REMARKS

In the outstanding non-final Office Action of July 14, 2004, the Examiner objected to the drawings under 37 CFR 1.83(a) as allegedly not showing every feature specified in the claims; objected to the specification due to alleged informalities; rejected claims 2, 3, 10, 11, 18, 21, 25, 26, 29, 31, 32, and 35 under 35 U.S.C. 112, first paragraph as allegedly failing to comply with the enabling requirement; rejected claims 1, 4, 6-9, 12, 14-17, 19-20, 22-24, 27-28, 30, and 33-34 under 35 U.S.C. 102(e) as allegedly being anticipated by U.S. Patent No. 6,317,236 to Saunders; and rejected claims 5 and 13 under 35 U.S.C. 103(a) as allegedly being unpatentable over Saunders in view of U.S. Patent No. 6,128,313 to Chapman et al. ("Chapman"). Applicants traverse the objections and the rejections to the claims.

APPLICATION 09/752,828
ANNOTATED FIGURE

FIG. 5

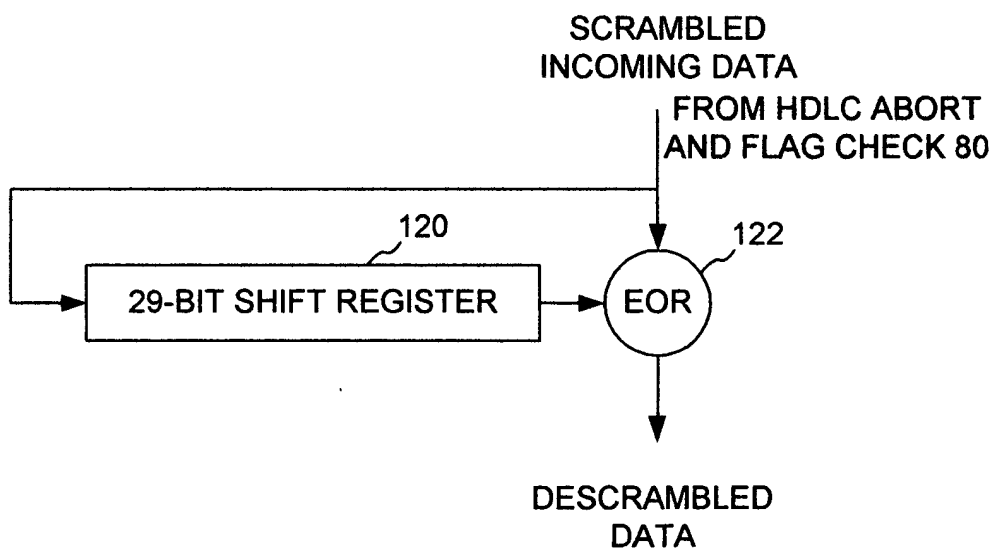
On page 2 of the Office Action, the Examiner objected to the drawings under 37 CFR 1.83(a) because the claim terms “an abort packet” of claim 2, “a runt packet” of claim 3, “an abort packet preparing element” of claim 10, “a runt packet preparing element” of claim of claim 11, “runt analyzer” and “discarding element” of claim 21, “an extractor” of claim 22, “creating an abort packet” of claim 25, “creating a runt packet” of claim 26, “abort packet element” of claim 31, “a runt packet element” of claim 33, and “a runt packet determining element” of claim 35 are not shown. The Examiner requested that the features be canceled from the claims or shown in the drawings.

With respect to Fig. 5, Applicants submit that the descrambling elements of Fig. 5 are not prior art. Fig. 5 shows the descrambling elements receiving scrambled incoming data from an HDLC abort and flag check. The prior art does not disclose the descrambling elements receiving scrambled incoming data from an HDLC abort and flag check.

With respect to page 9, lines 9-10, Applicants submit that the phrase “other elements for processing” is not indefinite. The phrase is included to indicate that that the

With respect to “EOR” of Fig. 5, Applicants submit that the term “EOR” is a term well known to those of ordinary skill in the art as indicating an “exclusive-or” operation. The term “EOR” has not been changed in Fig. 5.

elements of HDLC descrambler 82, shown in Fig. 5, are not limited to only the elements shown in Fig. 5, but may contain additional elements.

With respect to page 8, line 29, Applicants, as discussed above, submit that the descrambling elements of Fig. 5 are not prior art. Fig. 5 shows the descrambling elements receiving scrambled incoming data from an HDLC abort and flag check. The prior art does not disclose the descrambling elements receiving scrambled incoming data from an HDLC abort and flag check. Further, Applicants submit that the descrambler of Fig. 5 is not limited to that which is disclosed in Merchant. Therefore, a reference to the Merchant reference has not been included in the specification.
